RE: Percolation Test Results – A528406-A  
14010 Forsythe Rd

Percolation testing conducted on March 14, 2008 on the referenced property indicated satisfactory and unsatisfactory soil conditions. Copies of the test results are enclosed. Limiting factors include rock percentages >50% at shallow depths along with increased buffer depths to groundwater.

Percolation Certification Plan

HUDSON PROPERTY  
Lots 1, 2, & Buildable Preservation Parcel "A"  
Tax Map 8, Grid 6, Parcel 39  
4th Election District  
Howard County, Maryland

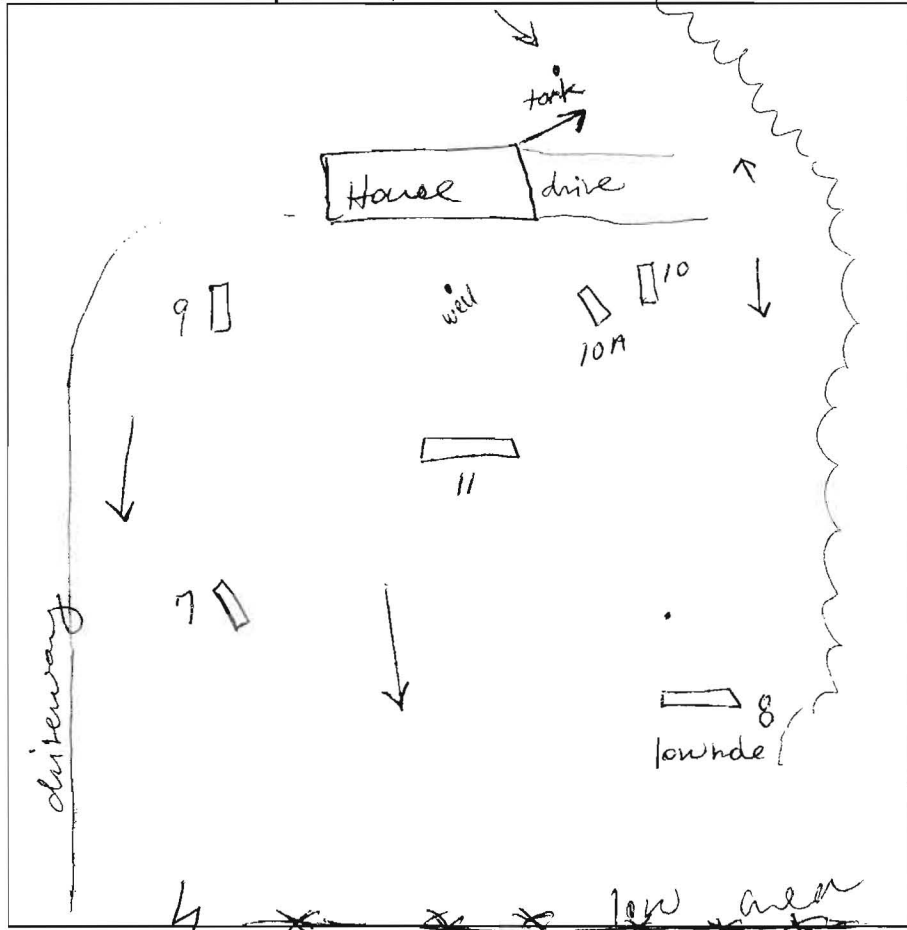
- 1) Actual surveyed locations and elevations of all excavated test holes. Hold 25' from test hole #5 to proposed SDA.
- 2) Proposed house site (55' x 70') or footprint, including building restriction lines as determined by other County agencies, and driveway location

- 19) Show the location of the abandoned septic trenches found during testing, and add to general notes a note related to the removal of the pipe and gravel at time of septic installation for that lot.

Parcel "A" A 520406-B

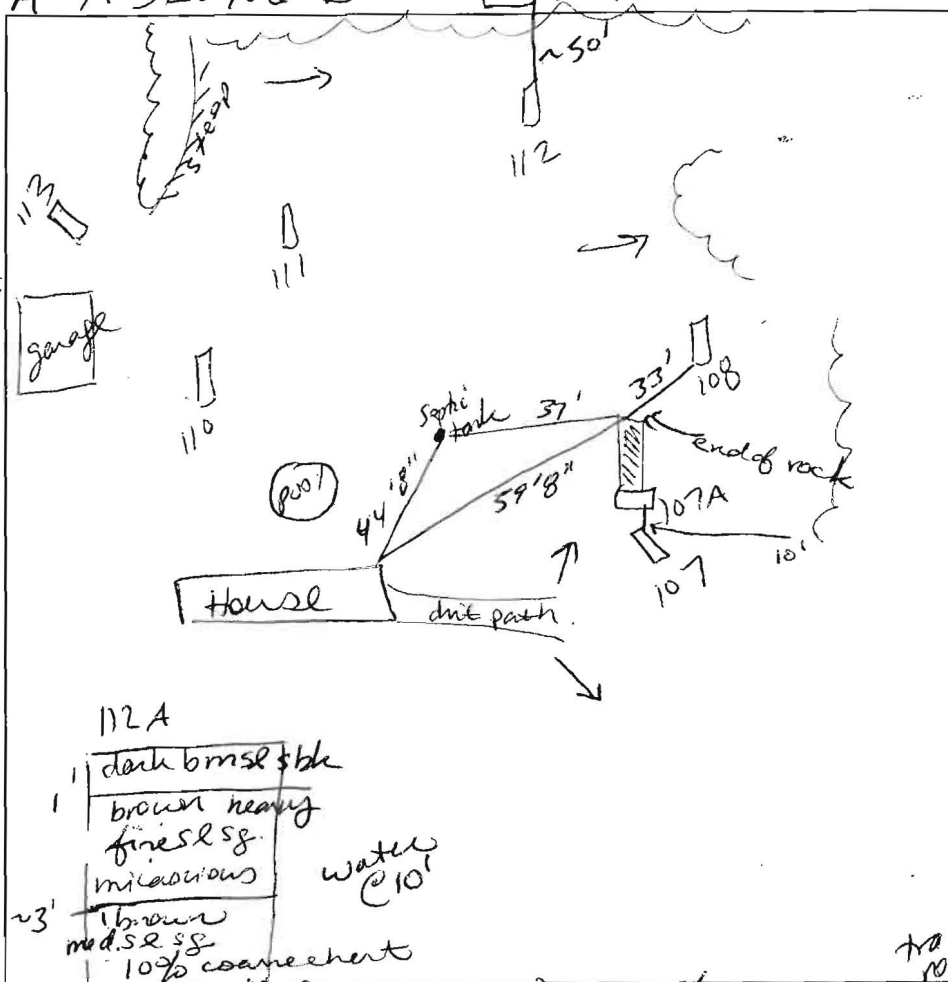
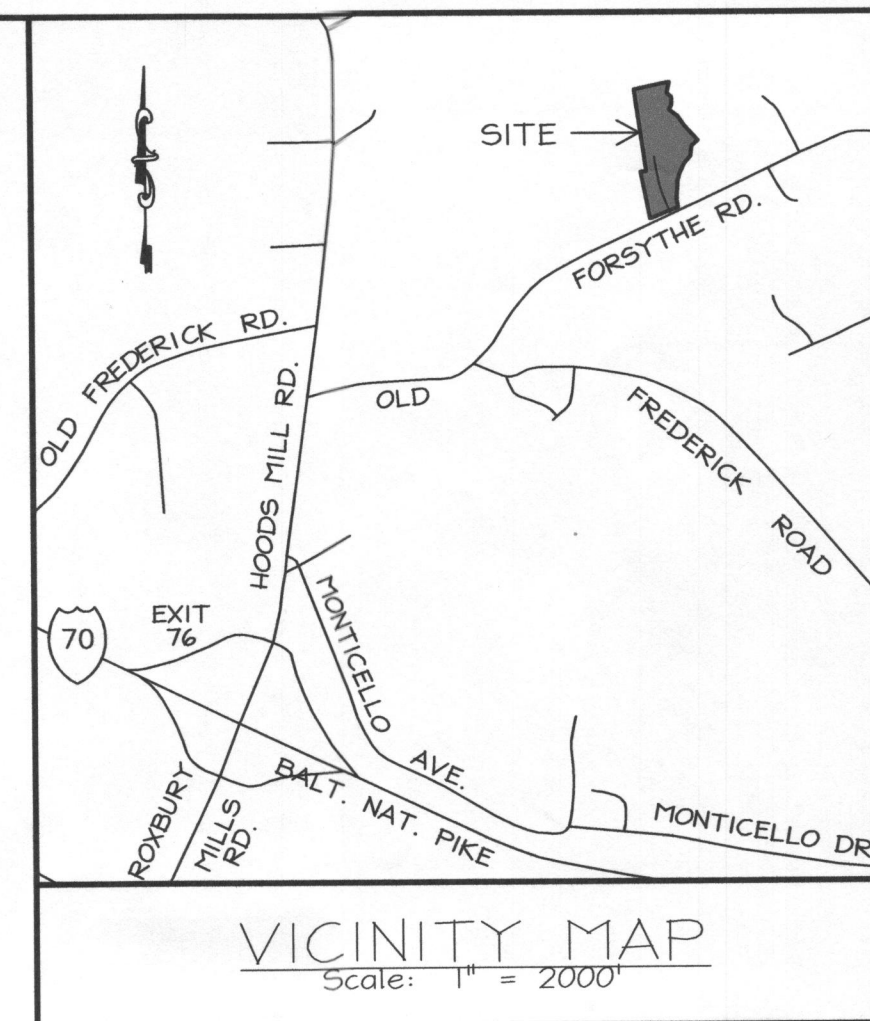
Remarks: Poked during wet season 108 6' buffer to water. Holes dug per stake - except # 112A + # 107A

Percolation testing conducted on April 25, 2008 on the referenced property indicated satisfactory and unsatisfactory soil conditions. Copies of the test results are enclosed. Limiting factors include rock percentages >50% at shallow depths along with increased buffer depths to groundwater.
